CITY OF ENCINITAS

QUIET ZONE FEASIBILITY ANALYSIS

**CITY OF ENCINITAS
QUIET ZONE FEASIBILITY ANALYSIS**

LEUCADIA Blvd
 AT-GRADE CROSSING

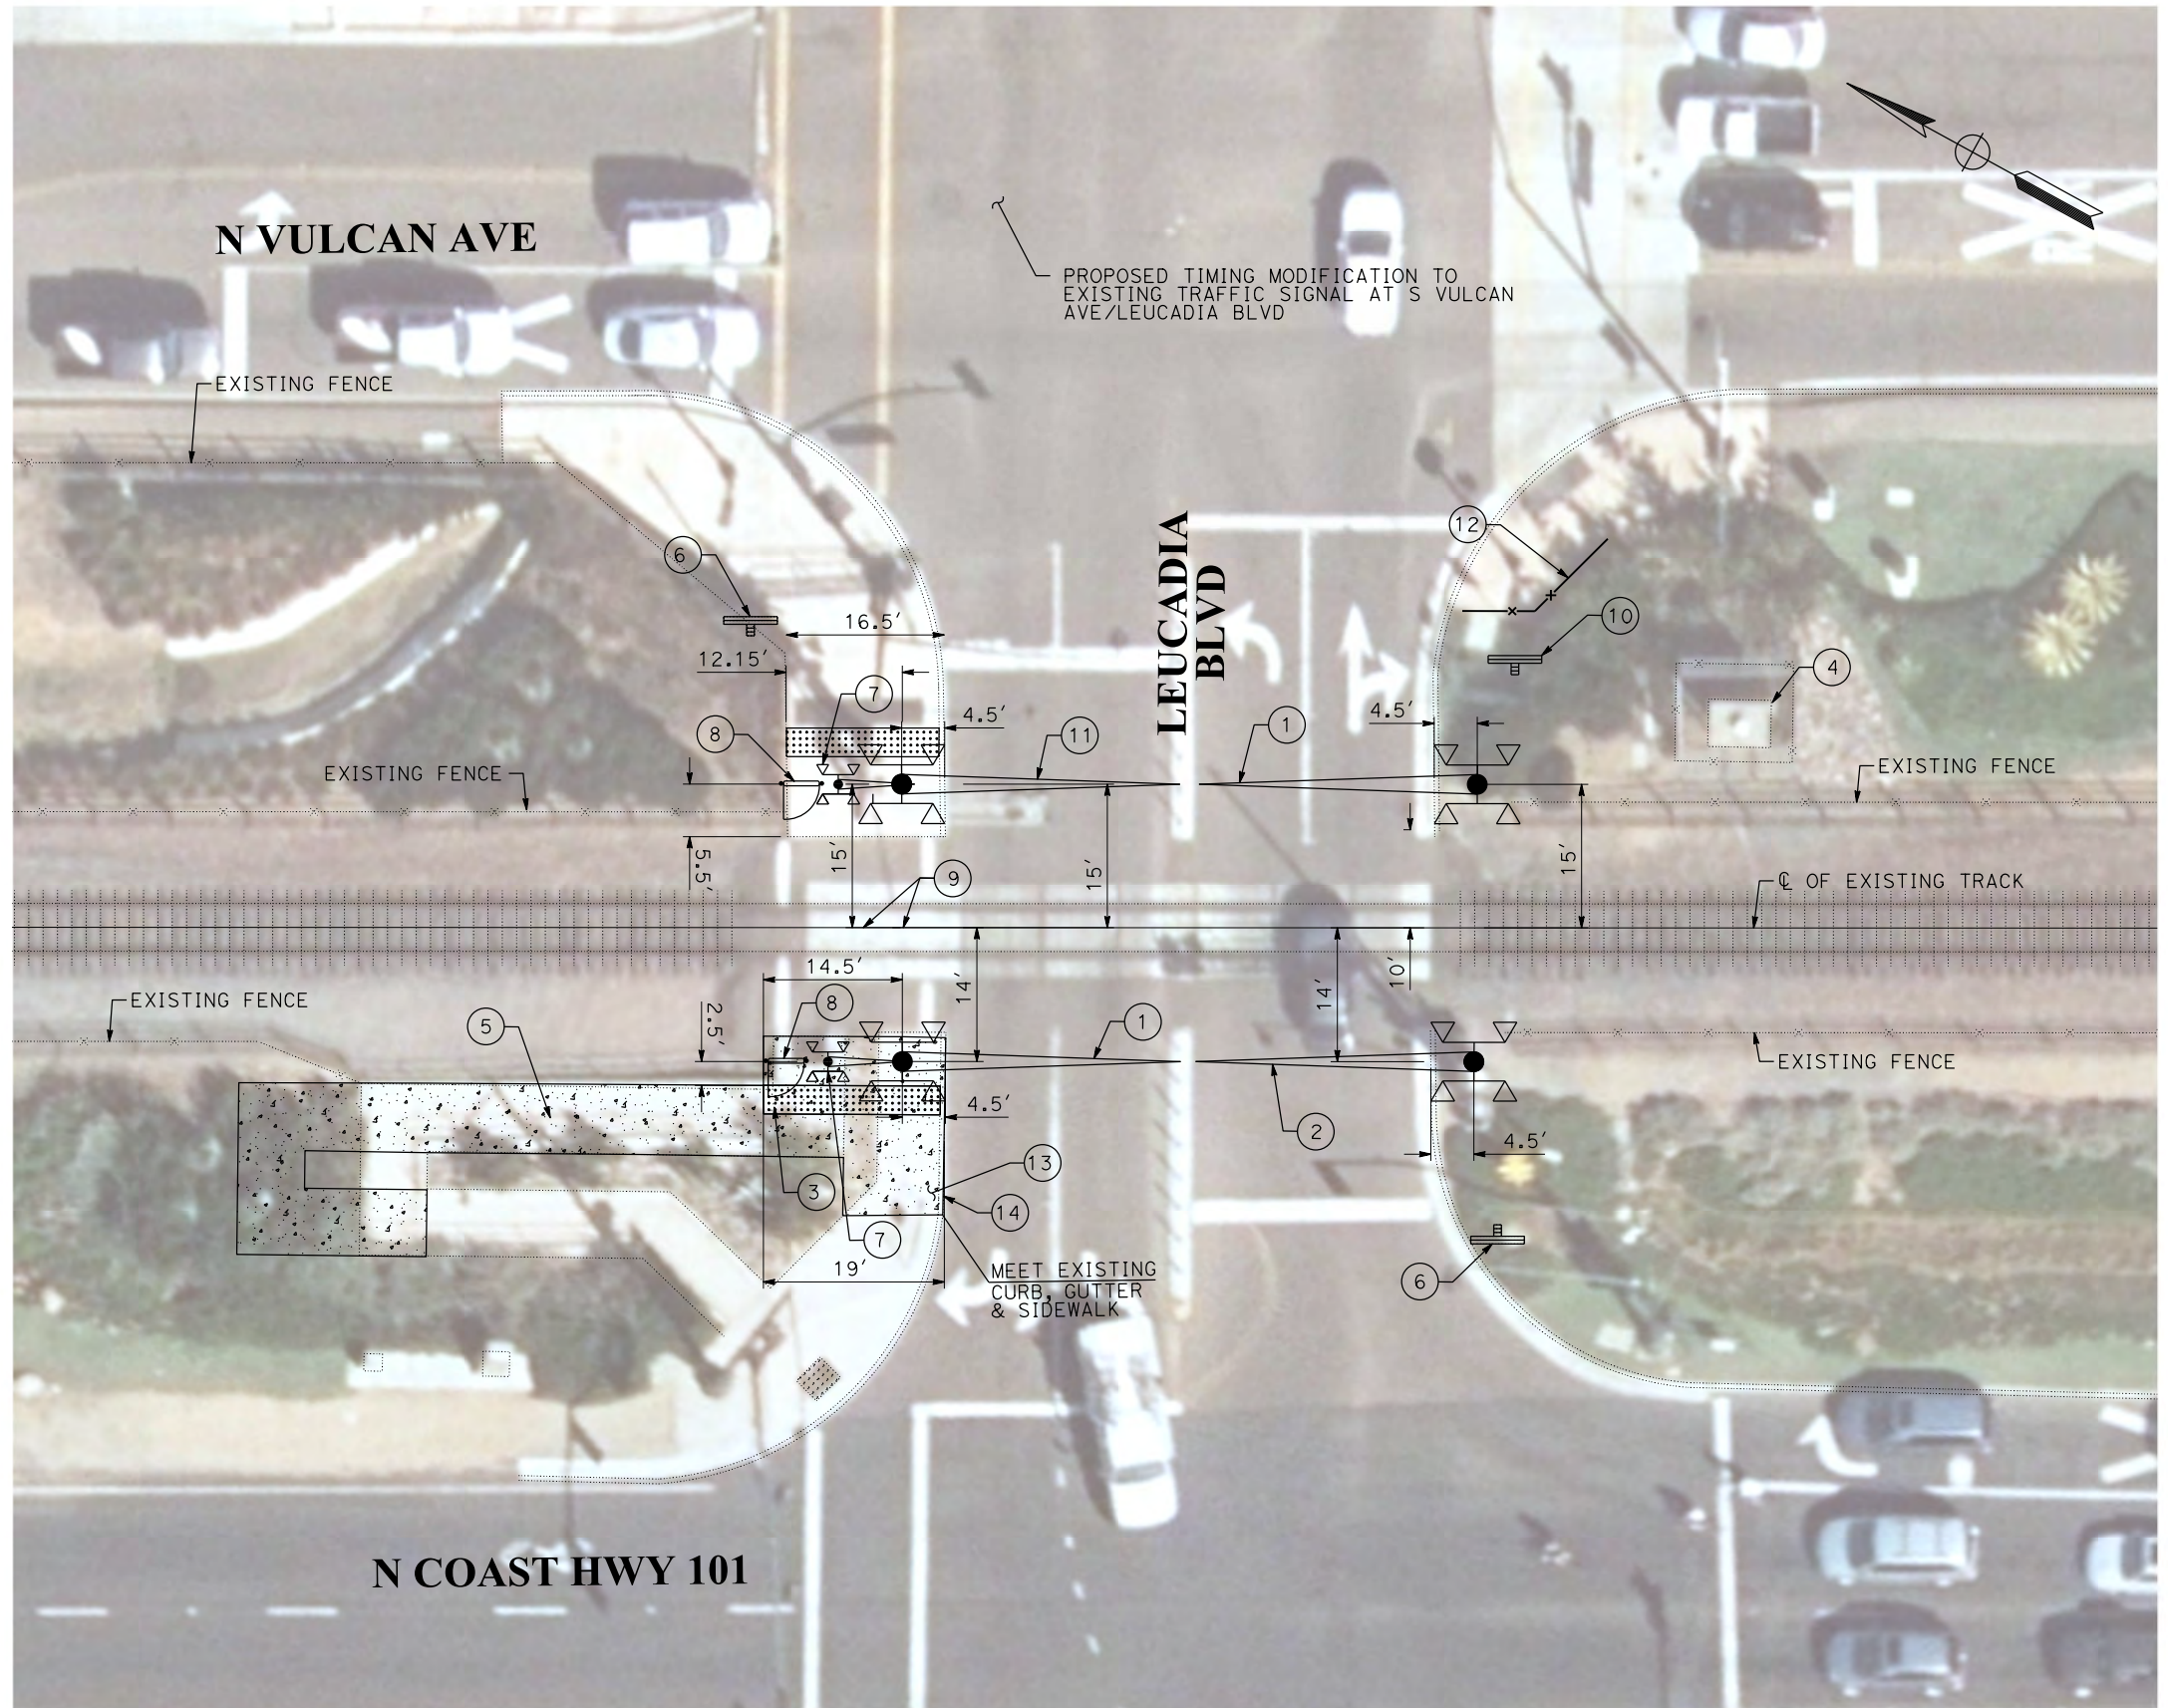
Site Diagnostic Meeting Comment	WSP Recommendation	WSP Remarks	Qty	Unit	Unit Price	Engineer's Estimate	
						All Items	Recommended
						\$ 84,440	\$ 64,440
LEUCADIA BOULEVARD							
Replace existing rubber panels with concrete panels	Included in original Project Cost Opinion						
Fill concrete panels lifting holes at pedestrian areas	RECOMMENDED	This is not strictly required for the Quiet Zone and is more of a "wish list" item. Estimated total of ~100 LF for Leucadia/D/E, split evenly.	33	LF	\$ 20	\$ 660	\$ 660
Extend tactile warning strip to cover entire width of pedestrian automatic gate arm and swing gate	RECOMMENDED	Includes the entire width of the pedestrian gate arm	54	SF	\$ 70	\$ 3,780	\$ 3,780
Reconfigure fencing and channelization of pedestrians on SE corner	RECOMMENDED	This is a planning-level estimate only, as no design was done to determine fencing configuration.	1	LS	\$ 10,000	\$ 10,000	\$ 10,000

Revise existing pedestrian ramps and tactile warning strips on NE and SE side to match revised orientation	NOT RECOMMENDED	This is not strictly required for the Quiet Zone and is more of a "wish list" item.	2	EA	\$ 10,000	\$ 20,000	
Add pedestrian gate arm assembly including flashers in NE quadrant. Possibly relocate vehicular gate arm	RECOMMENDED	Requires more width on sidewalk and relocation of the vehicular arm.	2	EA	\$ 10,000	\$ 20,000	\$ 20,000
Relocate CPUC No 9 gate	RECOMMENDED		1	EA	\$ 25,000	\$ 25,000	\$ 25,000
Modify signal timing to clear tracks	Included in original Project Cost Opinion						
Install additional signage on south side due to lack of pedestrian facility	RECOMMENDED		1	LS	\$ 5,000	\$ 5,000	\$ 5,000

E St
 AT-GRADE CROSSING

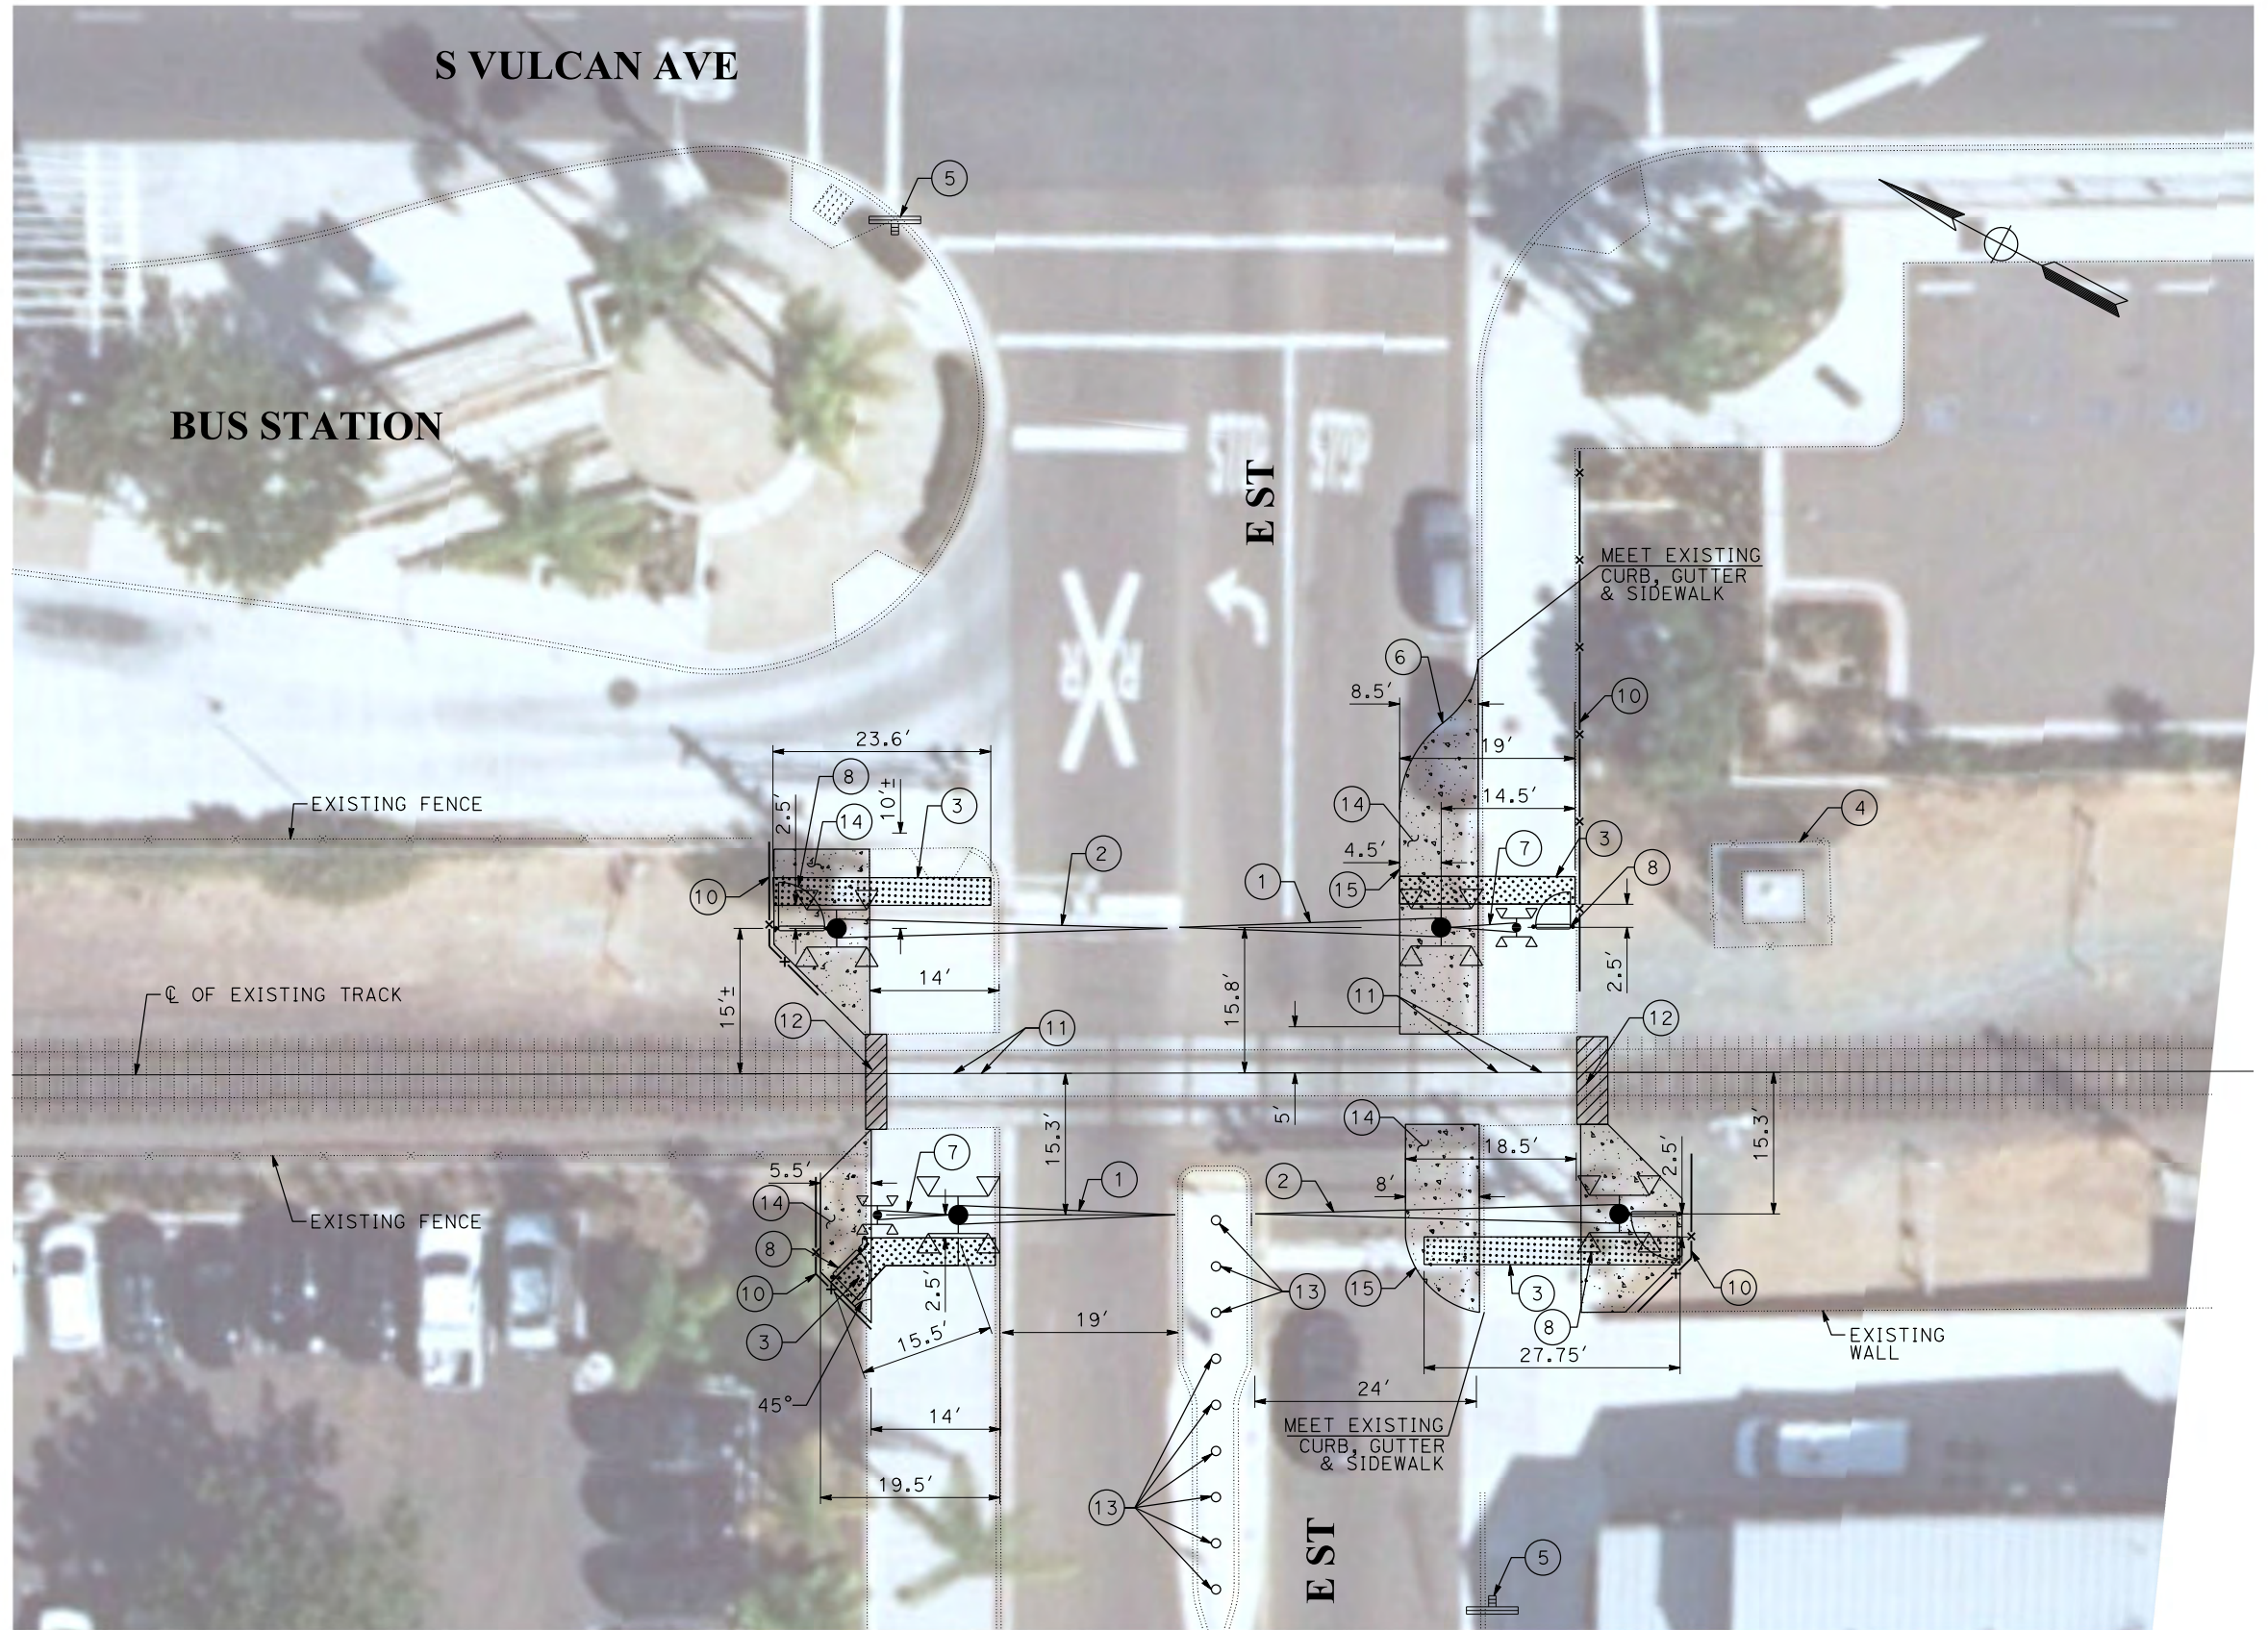
Site Diagnostic Meeting Comment	WSP Recommendation	WSP Remarks	Qty	Unit	Unit Price	Engineer's Estimate	
						All Items	Recommended
D STREET						\$ 370,060	\$ 135,060
Replace existing panels to meet NCTD gap requirements where additional panels are added	RECOMMENDED		90	TF	\$ 500	\$ 45,000	\$ 45,000
Fill concrete panels lifting holes at pedestrian areas	RECOMMENDED	This is not strictly required for the Quiet Zone and is more of a "wish list" item. Estimated total of 100 LF for Leucadia/D/E, split evenly.	33	LF	\$ 20	\$ 660	\$ 660
Extend tactile warning strip to cover entire width of pedestrian automatic gate arm and swing gate	RECOMMENDED		90	SF	\$ 70	\$ 6,300	\$ 6,300
At NE corner, relocate vehicle gate closer to the street and provide pedestrian gate and treatments	RECOMMENDED	Existing gate length exceeds current standard.	1	EA	\$ 18,000	\$ 18,000	\$ 18,000
Add pedestrian gate at NE corner	RECOMMENDED	This is not strictly required for the Quiet Zone but since the other 3 quadrants are adding the pedestrian gate, it makes sense to complete the crossing by adding this gate. Cost is for the gate only.	3	EA	\$ 18,000	\$ 54,000	\$ 54,000

Install median island on both sides of track	NOT RECOMMENDED	This is not strictly required for the Quiet Zone per the FRA calculator. Since we are proposing quad gates, a driver should not be able to drive around the gates, which is also the intent of the median.	250	LF	\$ 40	\$ 10,000	
Add bus signal for SE side	NOT RECOMMENDED	This is not strictly required for the Quiet Zone. It is an operational issue that NCTD needs to look further into, but the City should not be required to install this for the Quiet Zone.	1	EA	\$ 200,000	\$ 200,000	
Modify signal for increased preemption time	Included in original Project Cost Opinion						
Add "Keep Clear" markings	RECOMMENDED		2	EA	\$ 500	\$ 1,000	\$ 1,000
Add physical barriers between platform and sidewalk to channelize pedestrians	RECOMMENDED	Could consist of railing to channelize pedestrians.	1	LS	\$ 10,000	\$ 10,000	\$ 10,000
Conduct pedestrian traffic study from D Street to the Station platform	NOT RECOMMENDED	This is not strictly required for the Quiet Zone. FRA may request it to verify the impacts of pedestrian channelization.	1	LS	\$ 5,000	\$ 5,000
